Title: 702/720 East Washington Avenue Mixed-Used Development (Working Name)

Re: Letter of Intent – Façade Design Progression
Project: 702/720 East Washington Mixed-Use Development (Working Name)
JLA Architects Project #W22-0106

The items listed below and outlined on the included elevations are design progressions the team has made for the new 720 Mixed Use Building. This package outlines the changes between the previous approvals and the proposed plans.

PROFILE SERIES METAL PANEL 4 (CENTRIA)

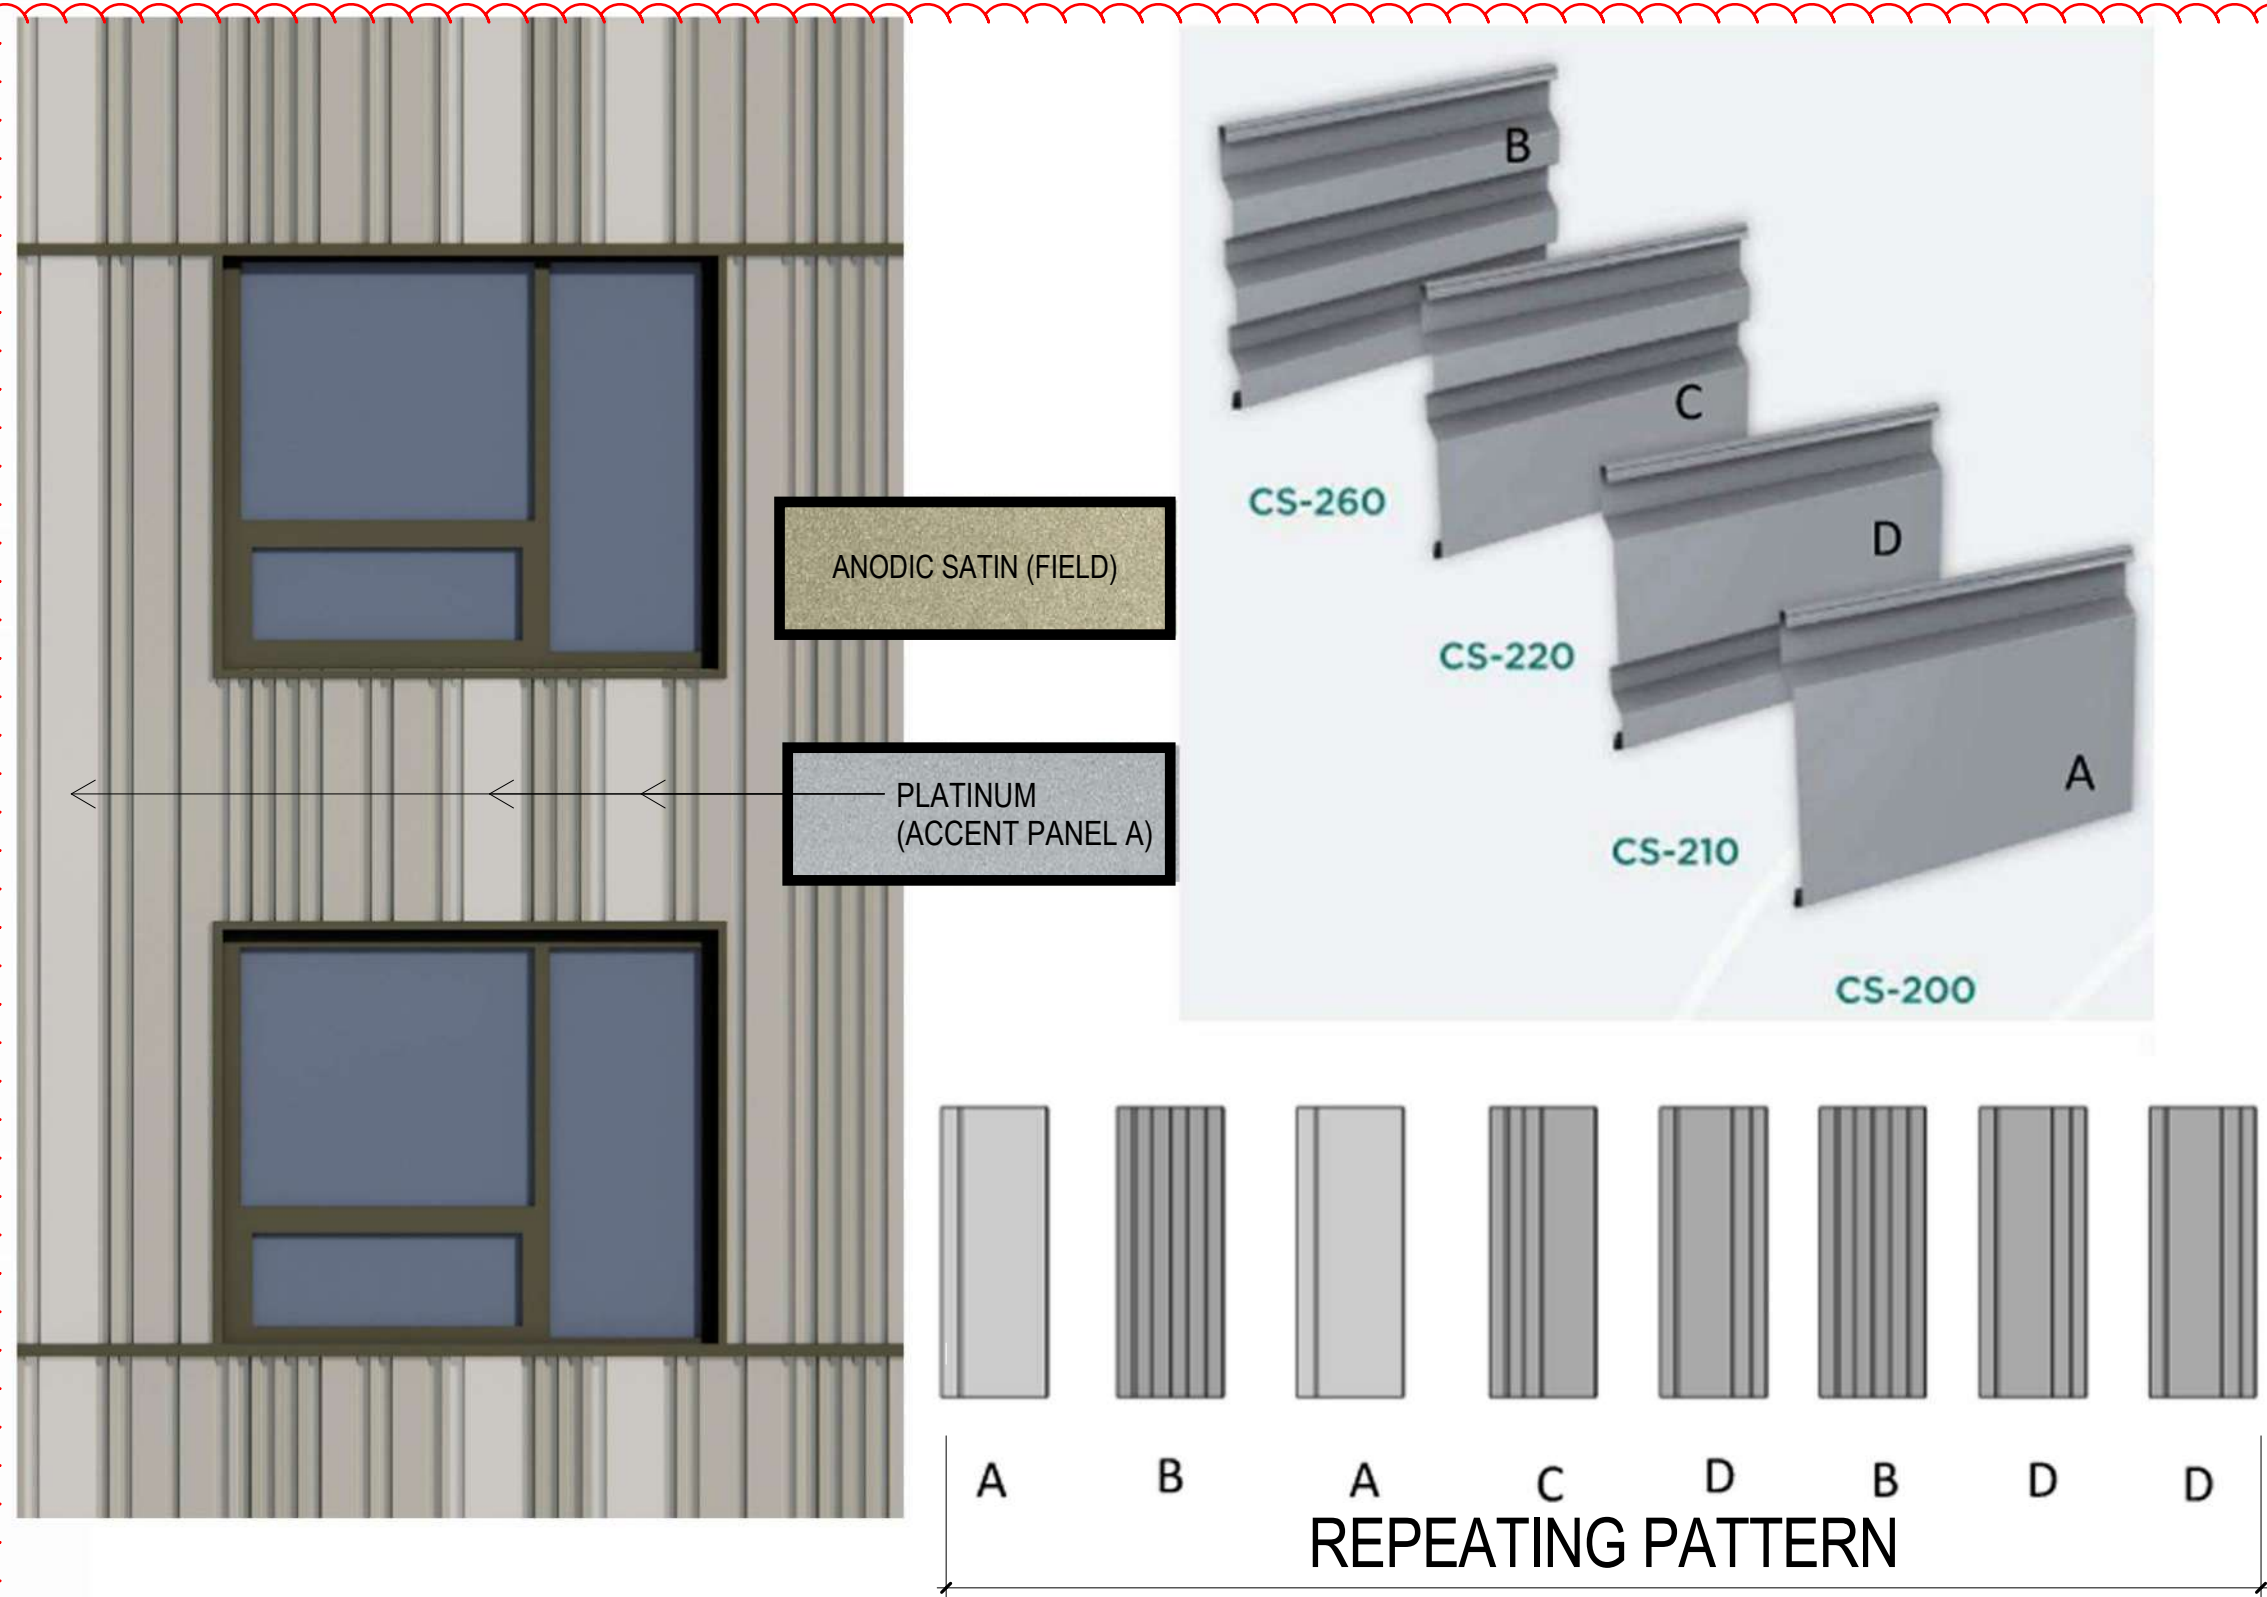
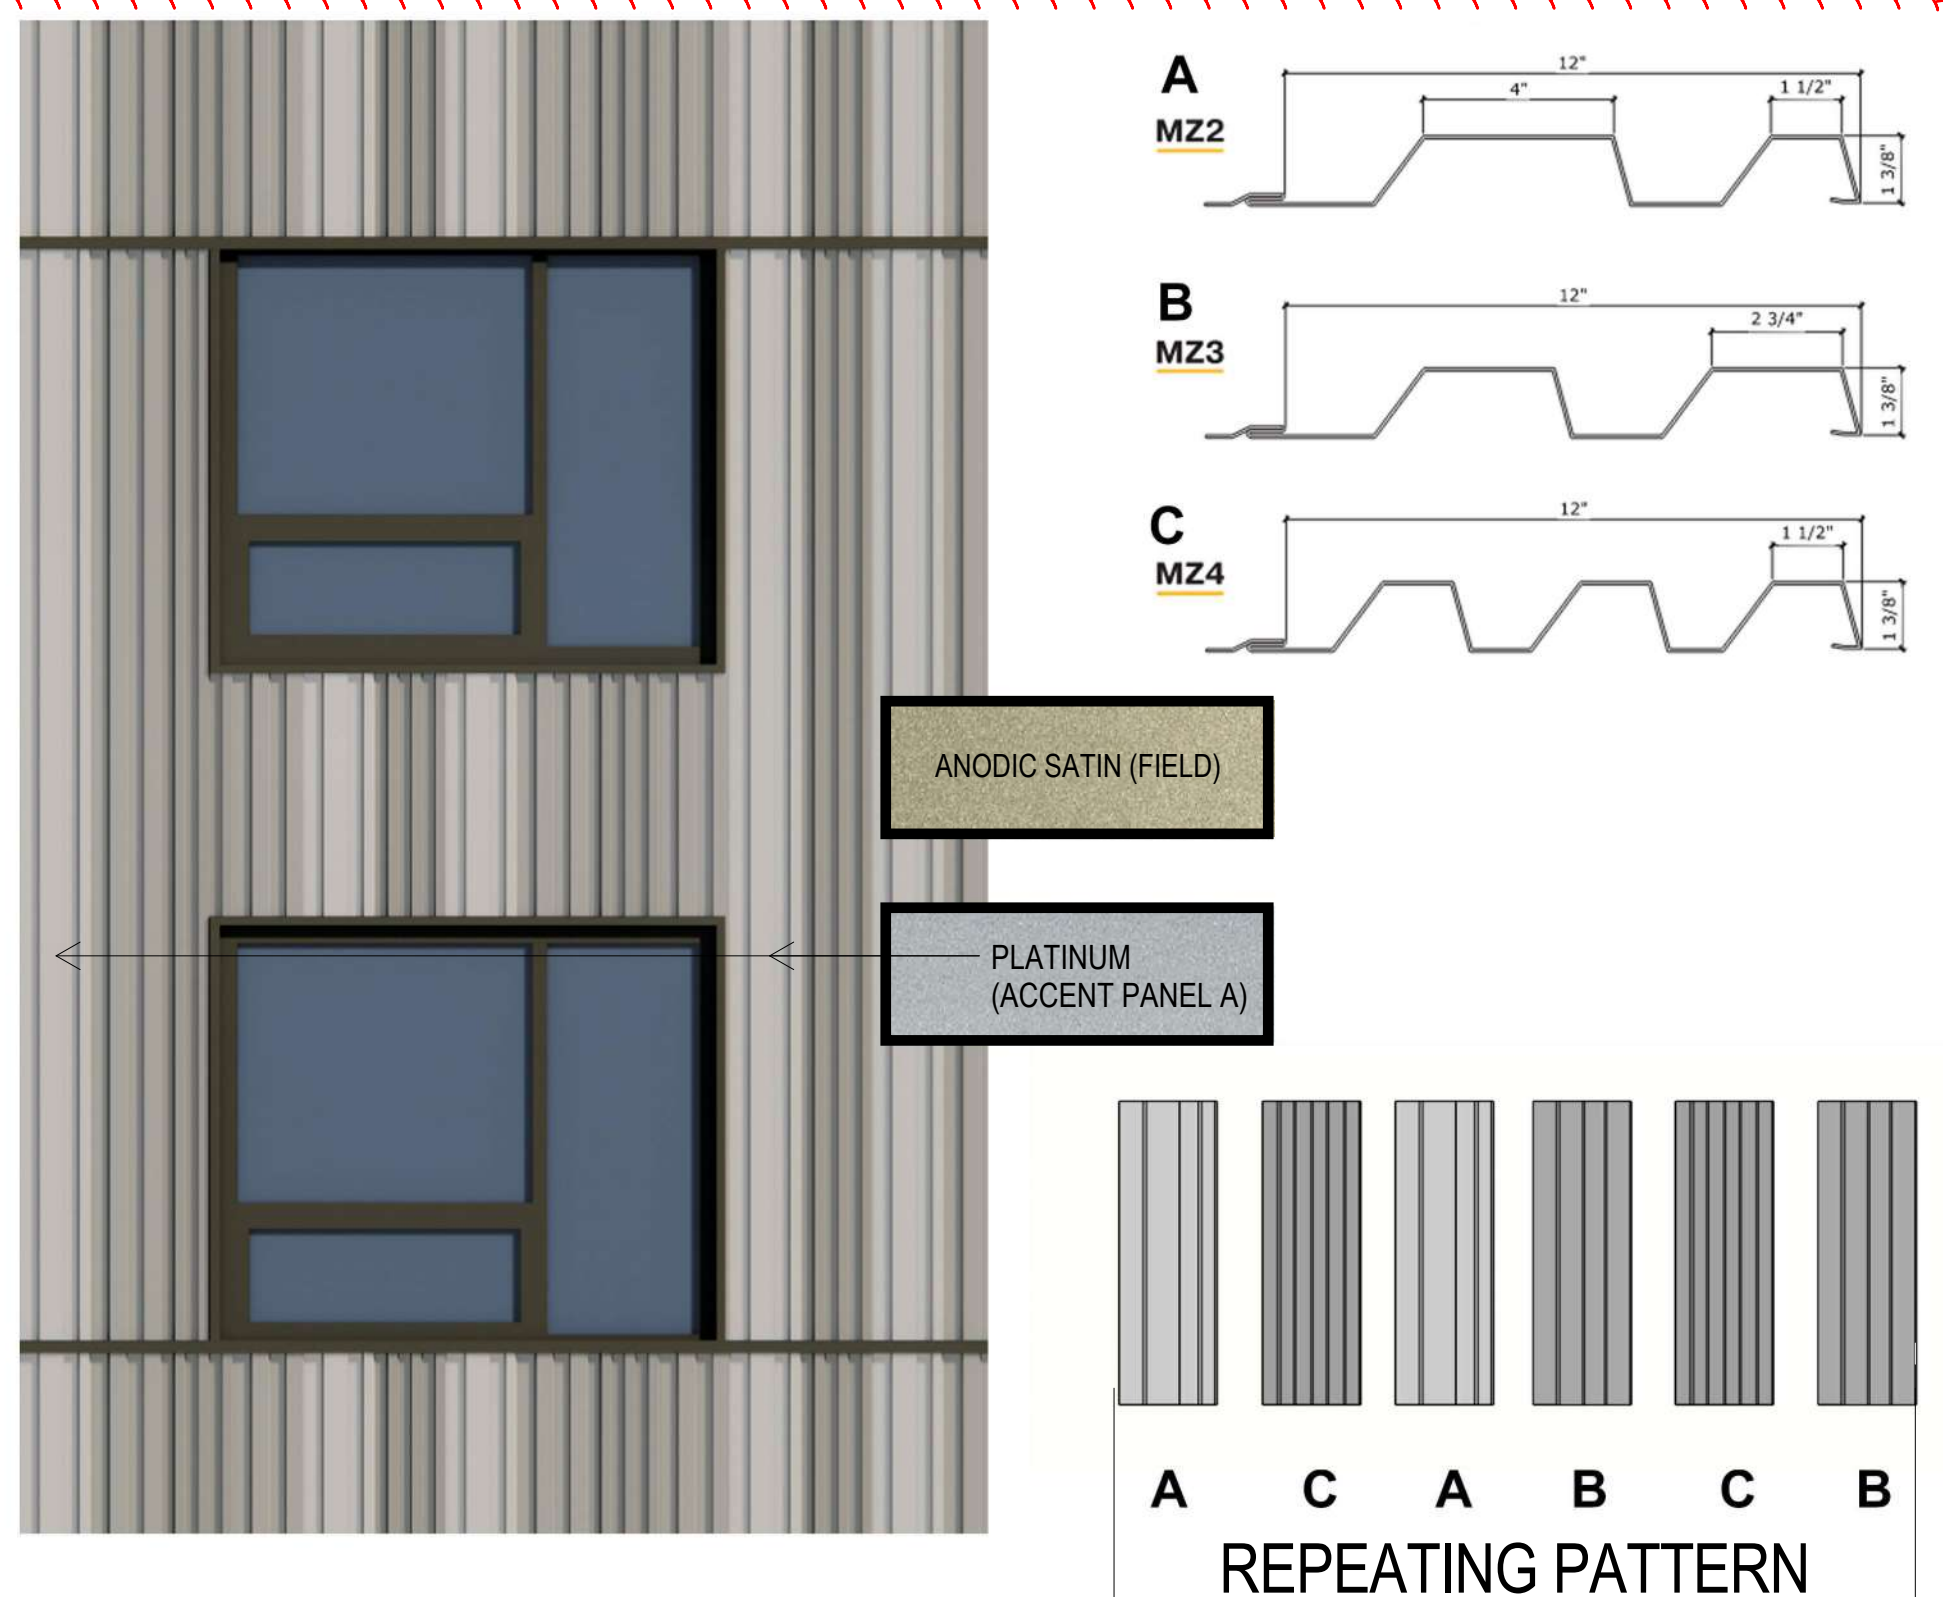
1. Changed to Centria or Muza panel instead of Metal Panel 3
 - a. We are proposing a change from flush metal panels to either Centria or Muza panel systems. This adjustment preserves the integrity of the building's base—primarily composed of masonry brick and large glazing expanses—while enhancing the vertical expression as the structure rises. Both Centria and Muza panels are being considered to achieve this effect, contributing dynamic interaction with light and offering a range of profiles that introduce texture and a rich color palette to the façade.

- b. While we believe Muza panels may provide a slightly stronger alignment with the original design intent, it is essential to maintain both Centria and Muza as viable options. Due to ongoing tariff uncertainty and market volatility, having dual options is critical to mitigate pricing risk and ensure the project remains on schedule and within budget. Each system supports the architectural vision, and preserving this flexibility is necessary for the project's successful delivery.
